V2500-A1 SERIES PROPULSION SYSTEMS SERVICE BULLETIN

This document transmits Revision 1 to Service Bulletin NV2500-71-0272 and Revision 1 to the Supplement

V2500-NAC-71-0272

NACELLE - ENGINE BUILD UNIT (EBU) - REPLACEMENT AND REROUTING OF SEVERAL EBU SYSTEMS TO ACCOMMODATE THE REROUTING OF THE OIL SCAVENGE TUBES

Removal of the Cabin Air Tube Figure 1 Sheet 1 of 2

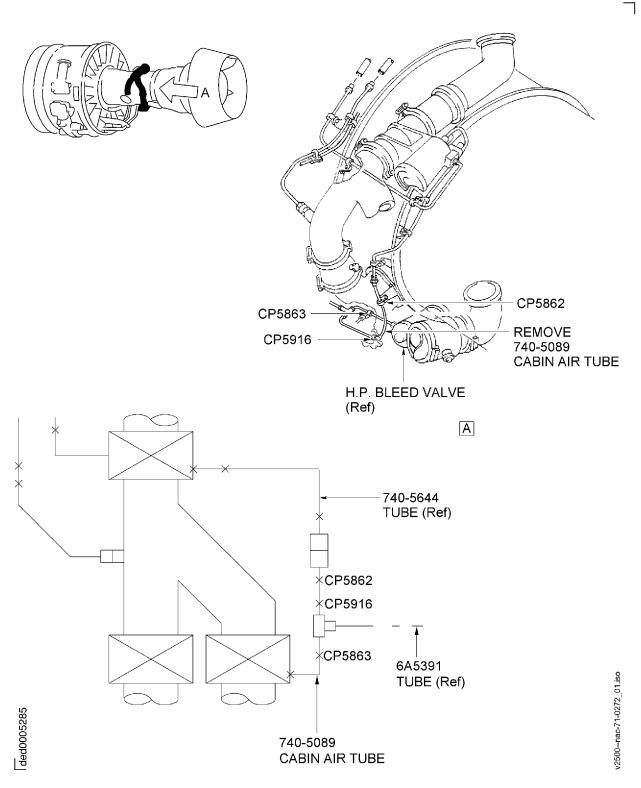
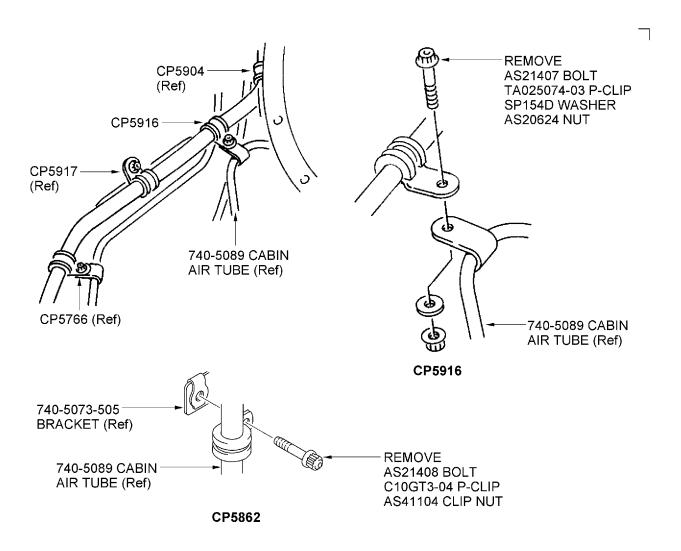
- (a) Clipping Point CP5916 Remove the AS20624 Nut, the SP154D Washer, the AS21407 Bolt and the TA025074-03 P-Clip
- Refer to Figure 1. Clipping Point applicable to Engine Buildup Units prior to VO280 that have not done SB V2500-NAC-71-0138.
- (b) Clipping Point CP5862 Remove the AS21408 Bolt, the AS41104 Clip Nut and the C10GT3-04 P-Clip
- (c) Clipping Point CP5863 Remove the AS20624 Nut, the SP155D Washer, the ST1698D48 Spacer, the AS21414 Bolt and the C10GT3-04 P-Clip.
- (d) Cut and safety the Lockwire which safeties the Tube Connections.
- (e) Disconnect the 6A5391 Tube from the 740-5089 Cabin Air Tube.

- (f) Disconnect the 740-5089 Cabin Air Tube from the 740-5644 Tube.
- (g) Disconnect the 740-5089 Cabin Air Tube from the High Pressure Bleed Valve.
- (h) Remove the 740-5089 Cabin Air Tube from the Nacelle.
- (4) Remove the 7702-01 or 7702-02 Fire Detector

Removal of the Overheat Detector and Bracket Figure 2 Sheet 1 of 2

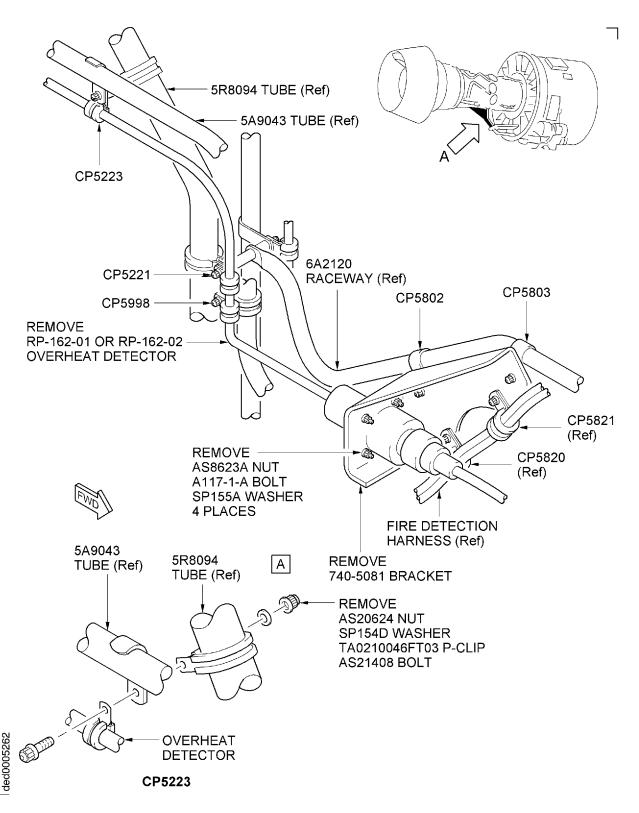
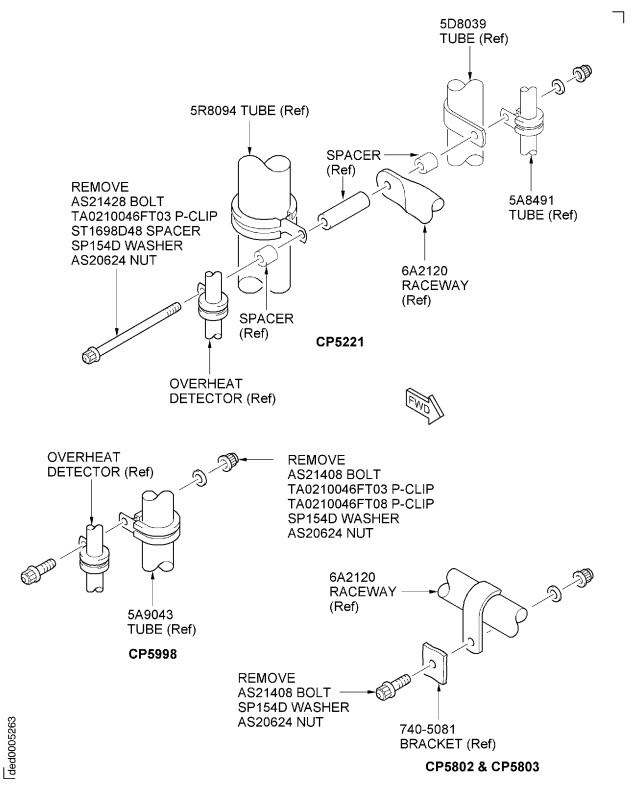
- (a) Clipping Point CP5223 Remove Refer to Figure 2. the AS20624 Nut, the SP154D Washer, the AS21408 Bolt and the TA0210046FT03 P-Clip
- (b) Clipping Point CP5221 Remove the AS20624 Nut, the SP154D Washer, the ST1698D48 Spacer, the AS21428 Bolt and the TA0210046FT03 P-Clip.
- (c) Remove the four AS8623A Nuts, the four SP155A Washers and the four A117-1-A Bolts to release the RP162-01 Overheat Detector from the 740-5081 Bracket.
- (d) Remove the RP162-01 Overheat Detector from the Nacelle.
- (7) Remove the RP162-02 Overheat Detector

(a) Clipping Point CP5223 - Remove Refer to Figure 2. the AS20624 Nut, the SP154D Washer, the AS21408 Bolt and the TA0210046FT03 P-Clip

- (b) Clipping Point CP5998 Remove the AS20624 Nut, the SP154D Washer, the AS21408 Bolt, the TA0210046FT03 P-Clip and the TA0210046FT08 P-Clip
- (c) Remove the four AS8623A Nuts, the four SP155A Washers and the four A117-1-A Bolts to release the RP162-02 Overheat Detector from the 740-5081 Bracket.
- (d) Remove the RP162-02 Overheat Detector from the Nacelle and retain.
- (8) Remove the 740-5081 Overheat Detector Bracket

- (a) Clipping Points CP5802 and Refer to Figure 2. CP5803 Remove the AS20624
 Nut, the SP154D Washer and the AS21408 Bolt to release the 740-5081 Bracket from the 6A2120 Raceway.
- (b) Remove the 740-5081 Overheat Detector Bracket from the Nacelle.
- (9) Partial removal of the 7827-02 Core Fire Detector

Removal of the Core Fire Detector Figure 3 Sheet 1 of 2

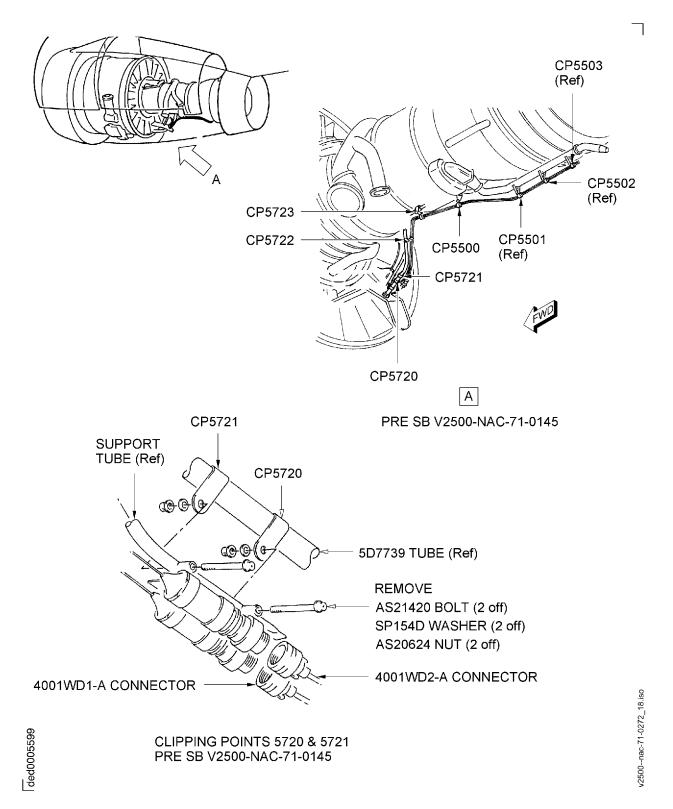
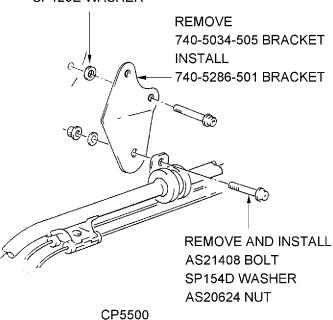
- (a) CP5720 and CP5721 Remove the Refer to Figure 3. AS20624 Nut, the SP154D Washer and the AS21420 Bolt
- (b) CP5722 Remove the AS20624 Nut, the SP154D Washer, the AS21408 Bolt and the C10GT3-08 P-Clip
- (c) CP5723 Remove the AS20624 Nut, the SP154D Washer, the ST1698D50 Spacer, the AS21408 Bolt and the C10GT3-08 P-Clip

- (d) CP5500 Remove the AS20624 Nut, the SP154D Washer and the AS21408 Bolt
- (e) CP5501, CP5502 and CP5503 -Loosen the AS21408 Bolts to allow the Fire Detector to move freely.
- (f) Remove the two 4W0167 Bolts and the two SP123E Washers to release the 740-5034-505 Bracket from the Engine.
 Retain the Bolts and Washers
- (g) Install the 740-5286-501 Bracket to the Engine with the two SP123E Washers and the two 4W0167 Bolts
- (h) CP5500 Install the Fire Detector to the 740-5286-501 Bracket with the AS21408 Bolt, the SP154D Washer and the AS20624 Nut.
- (i) Torque the 4W0167 Bolts to 75 - 85 lbfin (8,5 - 9,5 Nm)

(j) CP5500, CP5501, CP5502 and CP5503 - Torque the AS20624 Nuts to 36 - 45 lbfin (4 - 5 Nm) Torque the Nuts as instructed in the Aircraft Maintenance Manual, chapter 70-23-11.

Removal of the Core Fire Detector Figure 4

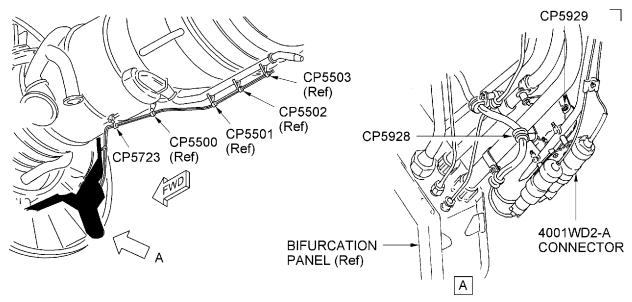
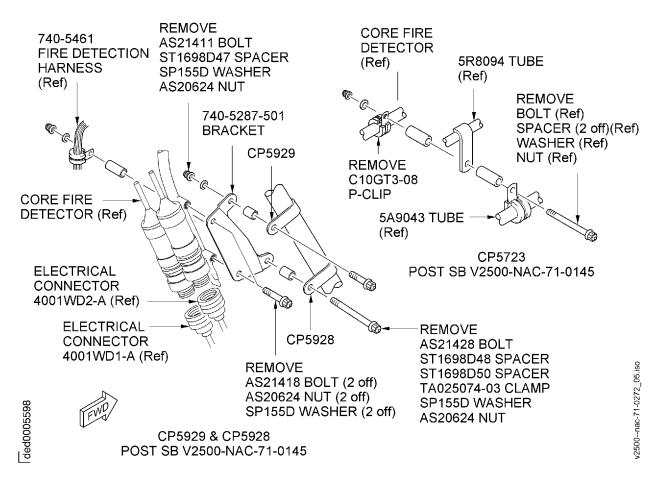
(a) Remove the two AS20624 Nuts, the two SP155D Washers and the two AS21418 Bolts to release the Fire Detector Responders from the 740-5287-501 Fire Detector Bracket. Retain the Bolts and Washers. Refer to Figure 4.

- (b) Clipping Point CP5928 Remove the AS20624 Nut, the SP155D Washer, the ST1698D48 Spacer, the ST1698D50 Spacer, the AS21428 Bolt and the TA025074-03 P-Clip.
- (c) Clipping Point CP5929 Remove the AS20624 Nut, the SP155D Washer, the ST1698D47 Spacer and the AS21411 Bolt to release the 740-5287-501 Fire Detector Bracket from the 6A5367 Pipe.
- (d) Remove the 740-5287-501 Fire Detector Bracket from the Nacelle.
- (e) At Clipping Point CP5723 remove the C10GT3-08 P-Clip.
- (11) Install the 740-5089-507 Cabin Air Tube

Installation of the Cabin Air Tube Figure 5

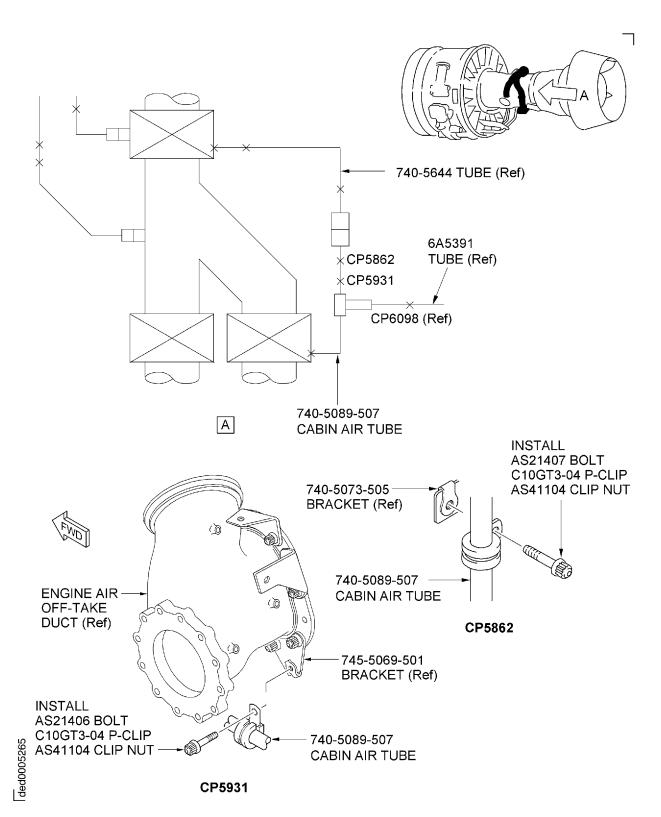
- (a) Apply CoMat 10-031
 Anti-galling compound to the threads of the new 740-5089-507 Cabin Air Tube
- Remove the applicable covers/caps/plugs from the Engine components.
- (b) Connect the 740-5089-507 Cabin Refer to Figure 5. Air Tube to the 740-5644 Tube.
- (c) Connect the 740-5089-507 Cabin Air Tube to the High Pressure Bleed Valve.
- (d) Connect the 6A5391 Tube to the 740-5089-507 Cabin Air Tube.
- (e) Clipping Point CP5862 Attach the 740-5089-507 Cabin Air Tube to the 740-5073-505 Bracket with the C10GT3-04 P-Clip, the AS41104 Clip Nut and the AS21407 Bolt

(f) Clipping Point CP5931 - Attach the 740-5089-507 Cabin Air Tube to the 745-5069-501 Bracket with the C10GT3-04 P-Clip, the AS41104 Clip Nut and the AS21406 Bolt Refer to SB V2500-ENG-79-0087 for the installation of the 745-5069-501 Bracket.

(g) Torque the end fittings on the 740-5089-507 Cabin Air Tube to 135 - 145 lbfin (15 - 16 Nm)

NOTE: Ensure that the Tube has a minimum clearance of 0.25 in (6,35 mm) with adjacent components and structure.

- (h) Torque the end fitting on the 6A5391 Tube to 159 177 lbfin (18 20 Nm).
- (i) Clipping Points CP5862 and CP5931 Torque the Bolts to 36 45 lbfin (4 5 Nm)

Installation of the 7702-04 Fan Case Fire Detector Figure 6 Sheet 1 of 2

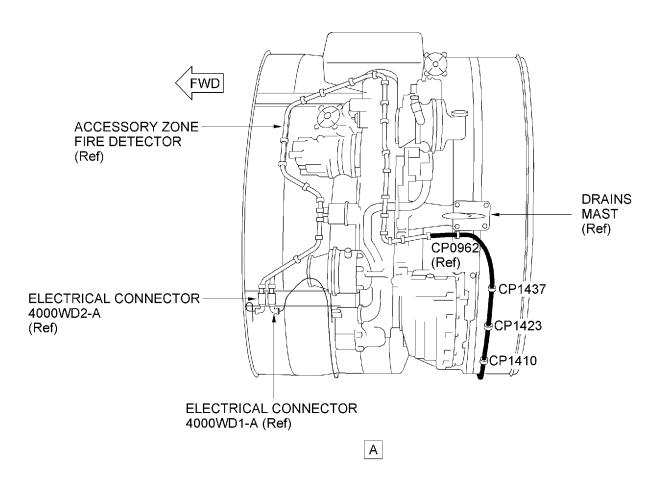
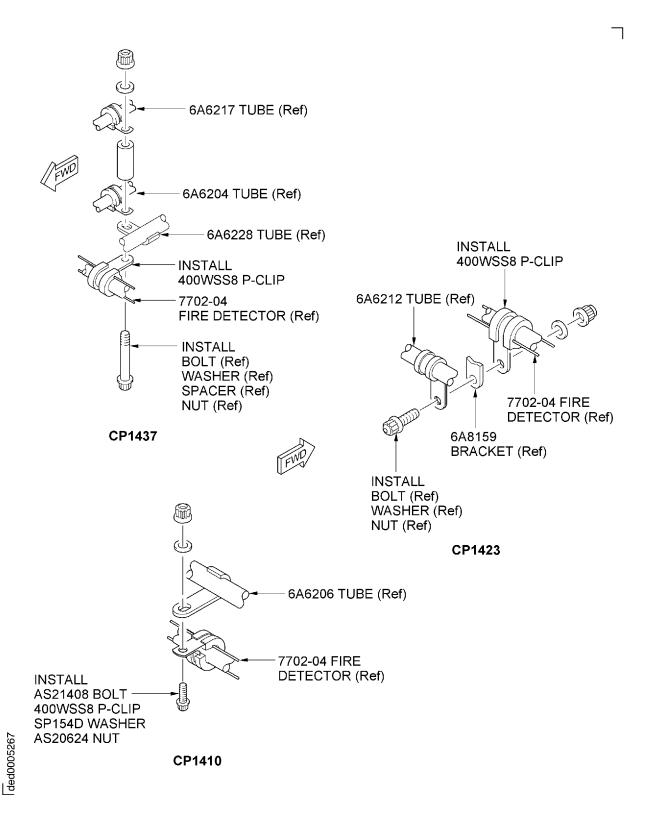
(a) Partially install the 7702-04 Fire Detector to the post SB V2500-NAC-26-0005 Configuration. Do not install Clipping Points CP0974, CP0975 and CP0976

(b) Clipping Point CP1437 - Attach the Fire Detector to the 6A6228 Tube, the 6A6204 Tube and the 6A6217 Tube with the 400WSS8 P-Clip Refer to Figure 6.

(c) Clipping Point CP1423 - Attach the Fire Detector to the 6A8159 Bracket and the 6A6212 Tube with the 400WSS8 P-Clip

(d) Clipping Point CP1410 - Attach the Fire Detector to the 6A6206 Tube with the 400WSS8 P-Clip, the AS21408 Bolt, the SP154D Washer and the AS20624 Nut Lubricate the Bolts with Engine oil CoMat 10-039 or CoMat 10-040.

(e) Clipping Points CP0777, CP0778, CP0955, CP0956, CP0957, CP0958, CP0941, CP0959, CP0960, CP0961, CP0962, CP1437, CP1423 and CP1410. Torque the AS20624 Nuts to 36 - 45 lbfin (4 - 5 NOTE: Ensure that the Fire Detector has a minimum clearance of 0.25 in (6,35 mm) with adjacent pipes and structure.

Installation of Clipping Point CP6115 on the Core Fire Detector Figure 7

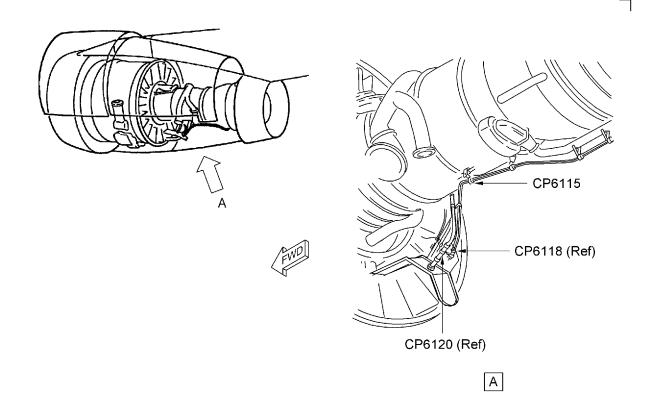
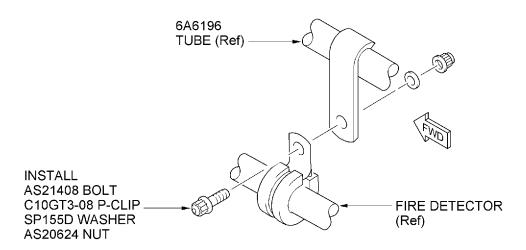
(a) Clipping Point CP6115 Install the Fire Detector to the 6A6196 Tube with the C10GT3-08 P-Clip, the AS21408 Bolt, the SP155D Washer and the AS20624 Nut

NOTE: Ensure that the Fire Detector has a minimum clearance of 0.25 in (6,35 mm) with adjacent pipes and structure.

(b) Torque the AS20624 Nut to 36 - 45 lbfin (4 - 5 Nm)

Installation of the Overheat Detector and Bracket Figure 8 Sheet 1 of 2

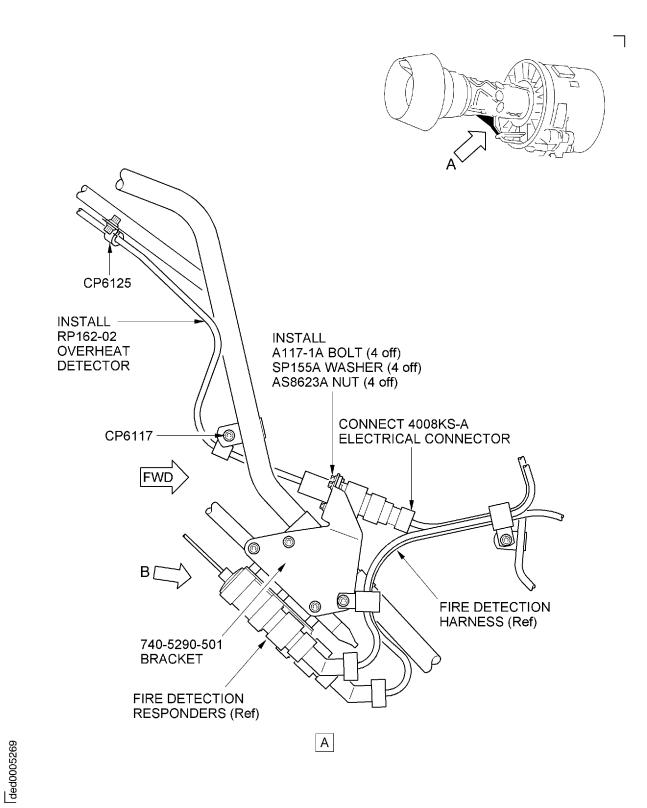
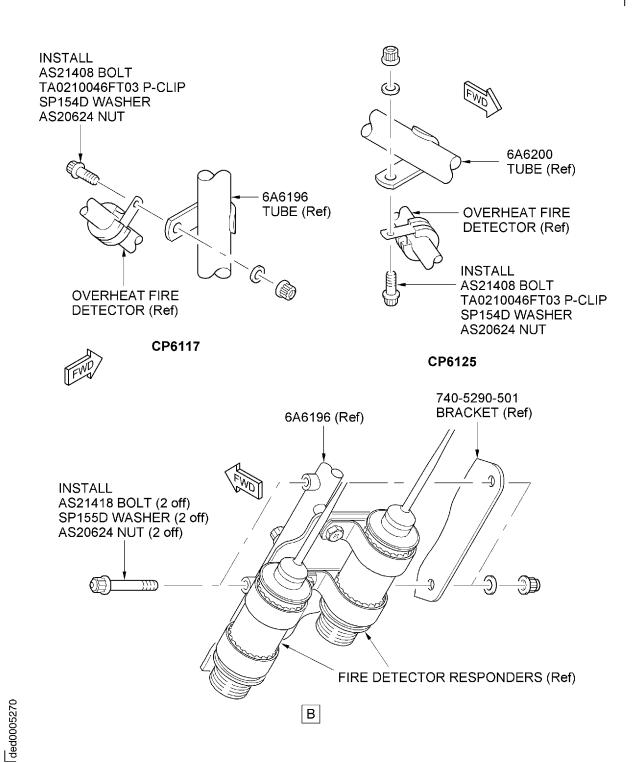
(a) Install the RP162-02 Overheat Detector to the 740-5290-501 bracket with the four A117-1-A Bolts, the four SP155A Washers and the four AS8623A Nuts

(b) Torque the AS8623A Nuts to 6 lbfin (0,68 Nm)

(a) Install the Fire Detector Responders to the 740-5290-501 bracket with the two AS21418 Bolts, the two SP155D Washers and the two AS20624 Nuts Refer to Figure 8.

Installation of the Fire Detection Harness (System A) Figure 9 Sheet 1 of 6

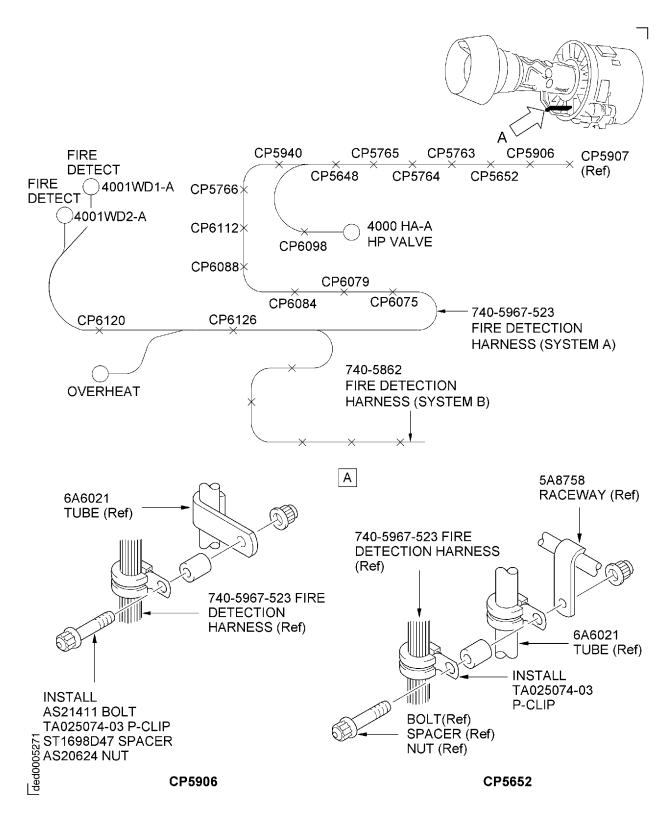
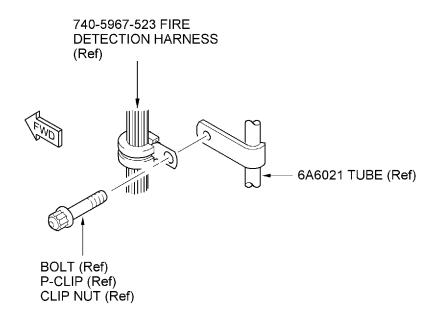
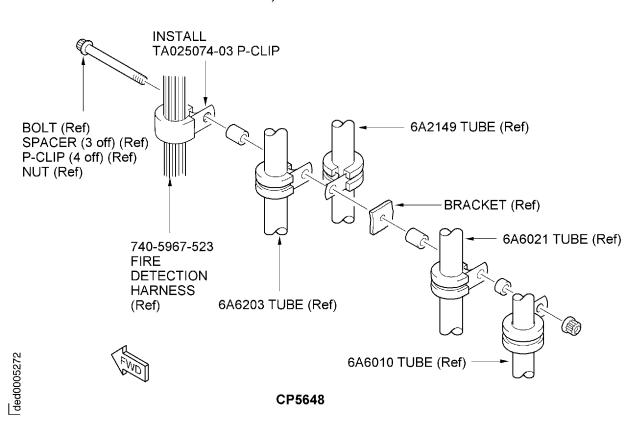
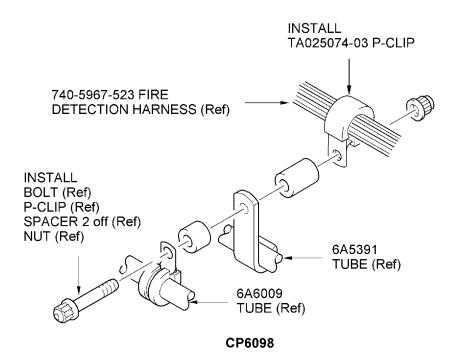
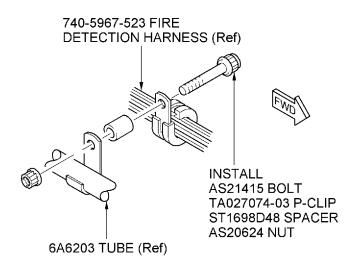
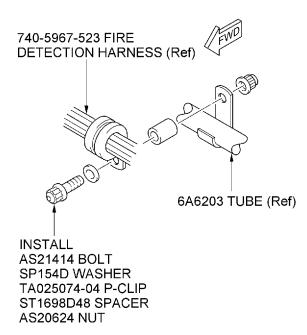
(e) CP5906 - Attach the Harness to the 6A6021 Tube with the TA025074-03 P-Clip, the AS21411 Bolt, the ST1698D47 Spacer and the AS20624 Nut Refer to Figure 9. Lubricate all Clipping Point Bolts and Nuts with Engine oil CoMat 10-039 or CoMat 10-040.
